Item No. 13.1.1
North West Community Council
May 13, 2019

SUBJECT: **Case 18276: Development Agreement for 74 Union Street, Bedford**

PROJECT: **UNION COURTYARD
OPTION B**

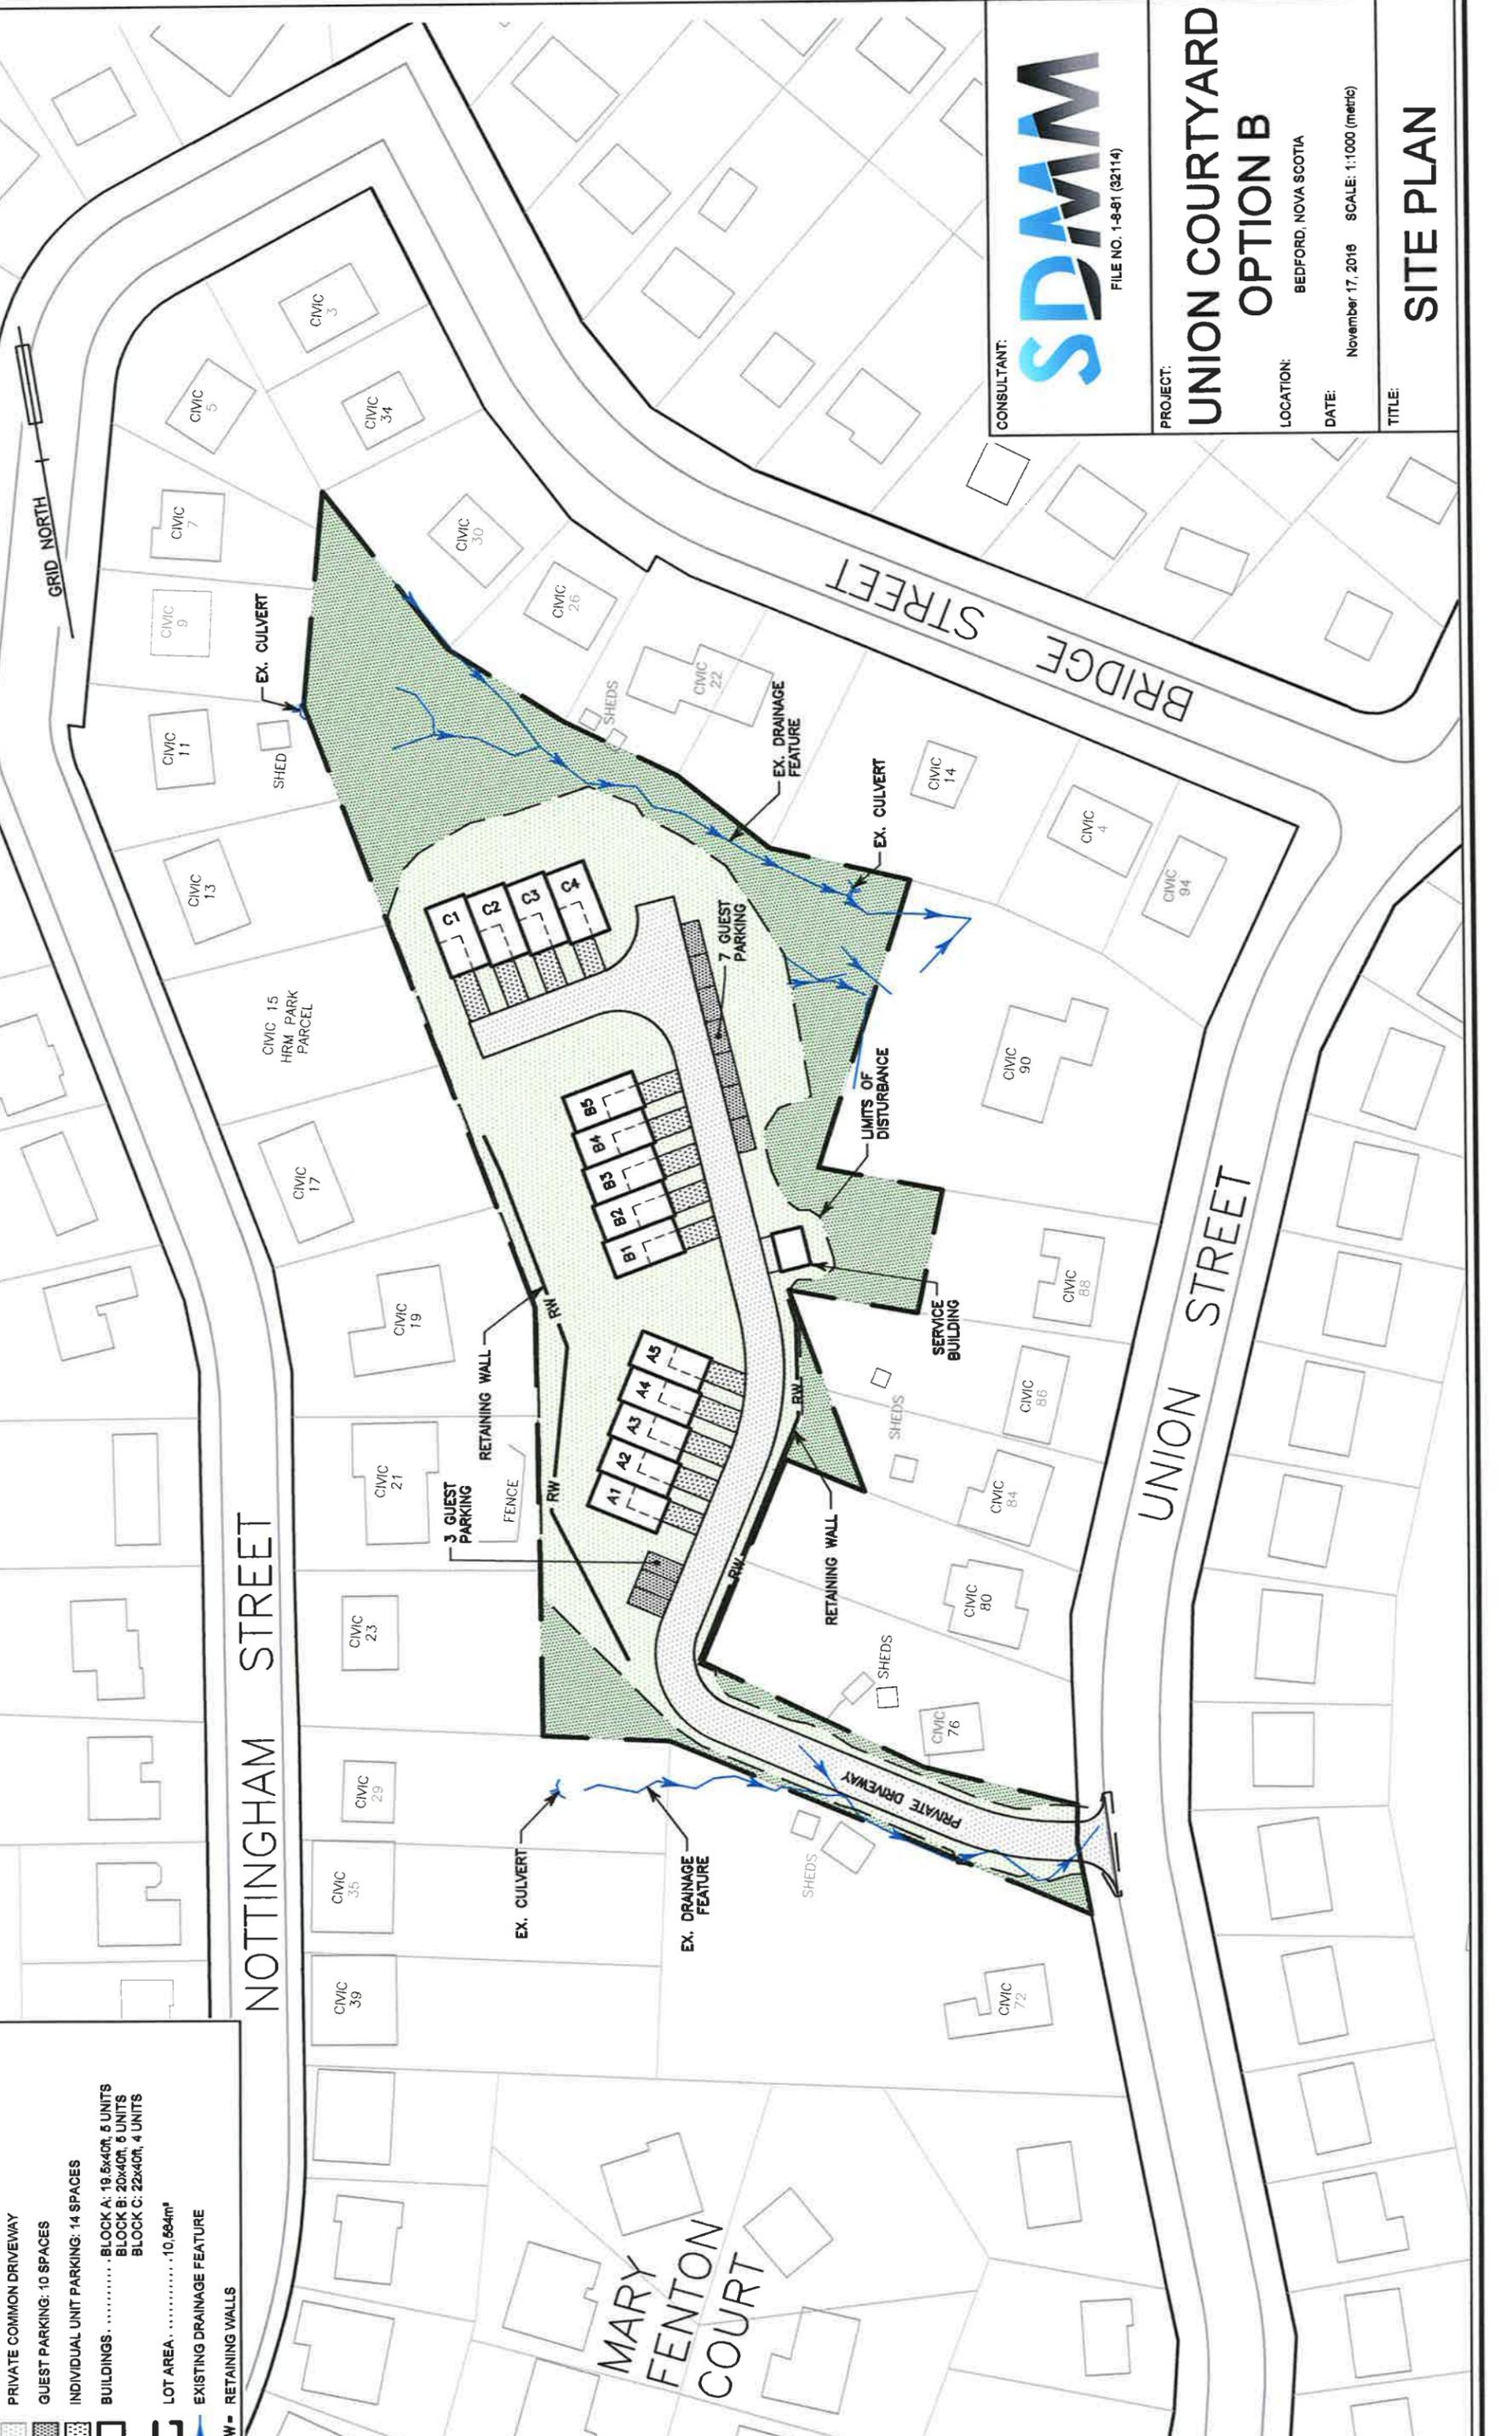
Member #5 - There is a concern regarding the storage of snow once cleared from the streets. Given the proposed layout of the development and the configuration of the roadways (particularly in Plan B) the natural tendency would be to push the snow off the roadway and down the embankment at the edge of the roadway on the northern side of the property. A buildup of snow in one area over the course of the winter can lead to excessive amounts of snow melt and runoff in that area during the spring melt particularly when coinciding with any heavy rainfall events. This concern can be addressed in the development agreement by assuring that barriers (natural or man made) exist to prevent this practice. The placement of barriers will also help to address excessive noise and light pollution from vehicles. Removal of excessive snow amounts offsite would be the preferred method of mitigation.
